STAFF REPORT

Department of Metropolitan Development Division of Planning Current Planning Section

Case Number: 2023-DV3-008 (Amended)
Address: 5030 Southport Crossing Place (approximate address)
Location: Perry Township, Council District #24
Zoning: C-4
Petitioner: McDonald's Corp., by Joseph D. Calderon
Request: Variance of Development Standards of the Consolidated Zoning and Subdivision Ordinance to provide for a restaurant remodel resulting in drive through service units and stacking spaces within the front yards of Emerson Avenue and Southport Road (not permitted), and without the required screening along the entirety of the drive through within the front yard of Southport Road or walkways connecting public entries to the sidewalk (required).

2023-DV3-008; Site Plan

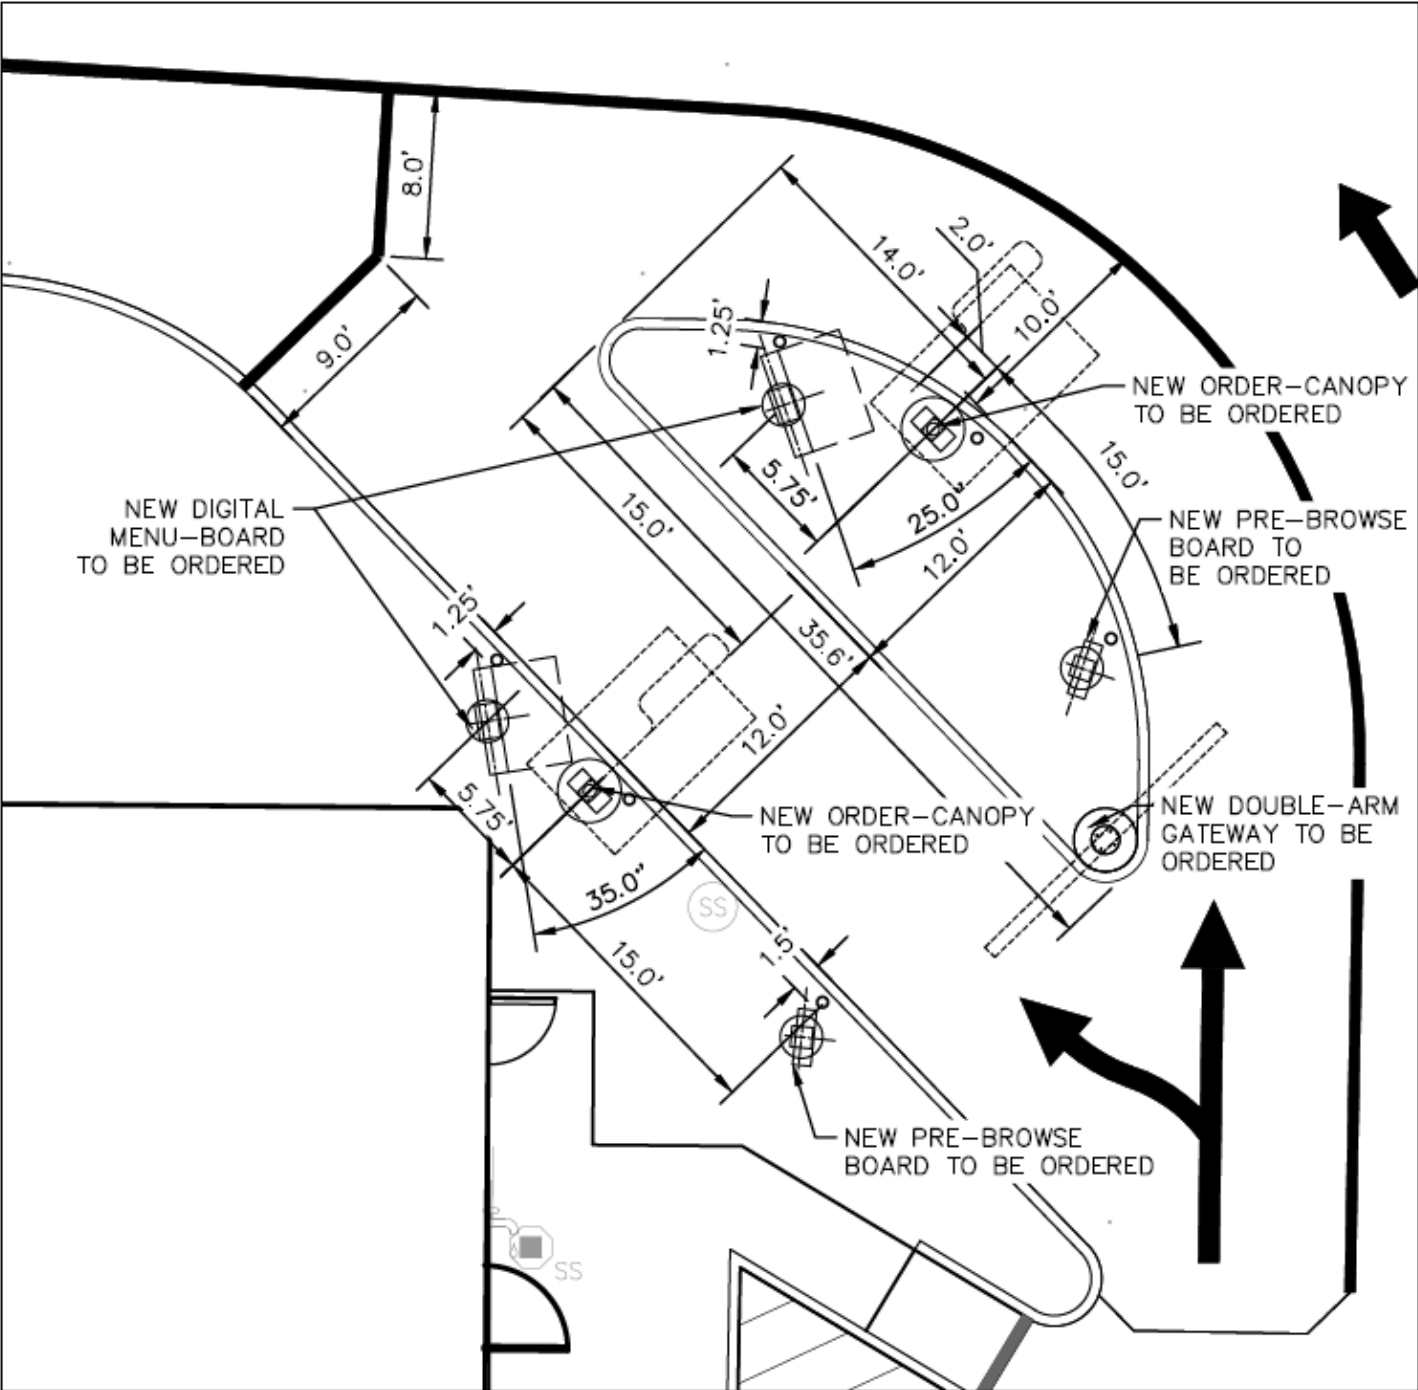
- ◇ The grant of the request would allow for a restaurant remodel resulting in drive through service units and stacking spaces within the front yards of Emerson Avenue and Southport Road without the required screening along the entirety of the front yard of Southport Road and without the required walkway connections.

- ◇ As proposed, two drive-through stacking lanes and associated ordering service units would be in front of the front building line without any additional landscaping provided. Shrubs at least three feet in height should be planted for improved screening to shield the headlights of the vehicles in the drive-through from the east and west bound traffic on Southport Road. Otherwise, the vehicles waiting in line would cause additional road hazards.

- ◇ The requested variances would be the result of an existing site layout and the desire to make changes to the building and site. Seven parking spaces would be removed to provide the additional room needed for a secondary lane and the required bypass lane.

- ◇ However, staff would argue that the elimination of the parking spaces along Southport Road would provide the opportunity for the front entrance to be relocated along the northern building façade with one row of parking in the front yard as permitted in a commercial district. This change could allow for the ordering lanes and stacking spaces to be relocated along the western and southern building façades outside of the front yard.

- ◇ The site would have sufficient space for maneuverability between the fueling stations and the southern building façade if the parking spaces were removed. Therefore, the proposed design of the site could be changed to meet the requirements of the Ordinance without the need for variances.

- ◇ Staff is recommending denial of the request due to a lack of practical difficulty with the use of the site since it could remain as is without an issue since the layout of the site is existing and was developed under a previous version of the Ordinance.
